SUBJECT: ARC-23-116 150 WORTH AVE—THE ESPLANADE

MEETING: SEPTEMBER 27, 2023 ARCOM

**ARC-23-116 150 WORTH AVE—THE ESPLANADE.** The applicant, Wilson 150 Worth LLC, has filed an application requesting Architectural Commission review and approval for the after-the-fact permanent removal of the existing second floor wood trellis along the Worth Avenue approved arcade of the Esplanade.

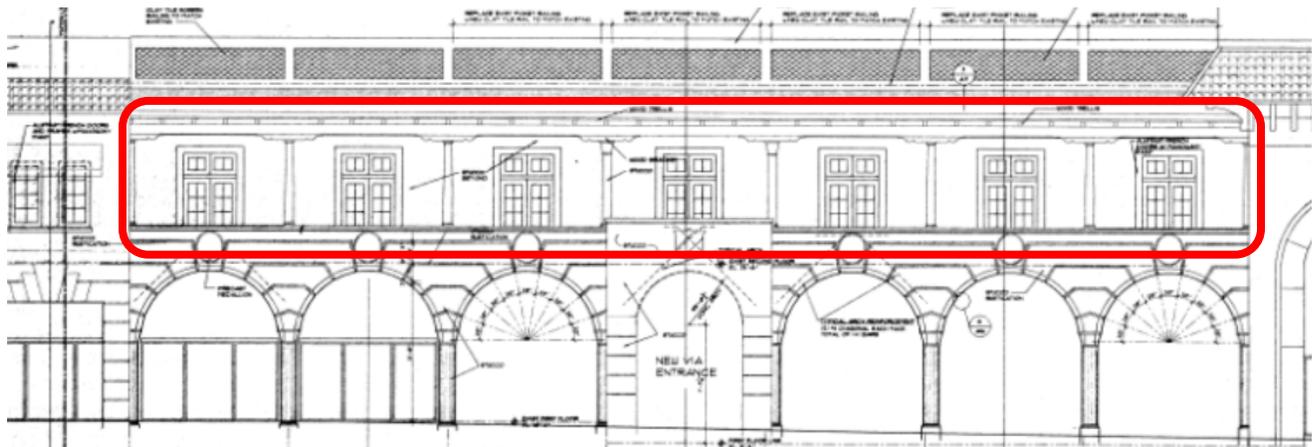
- After-the-fact permanent removal of non-original wooden trellis (over the arcade).

1998 Worth Avenue façade with new Arcade addition

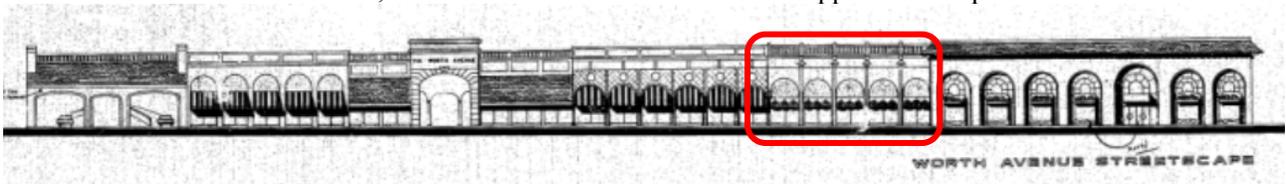
As outlined in the ‘History’ portion of the memo, the wooden trellis (and arcade) were not original architectural elements of the 1978 Gene Lawrence design. In fact, when approved in 1998, the wooden trellis at the second level required a height and setback variance.

Its removal technically brings the building closer to compliance under today’s zoning code, as the arcade and trellis required a setback variance and height variance. Staff has no concerns with the
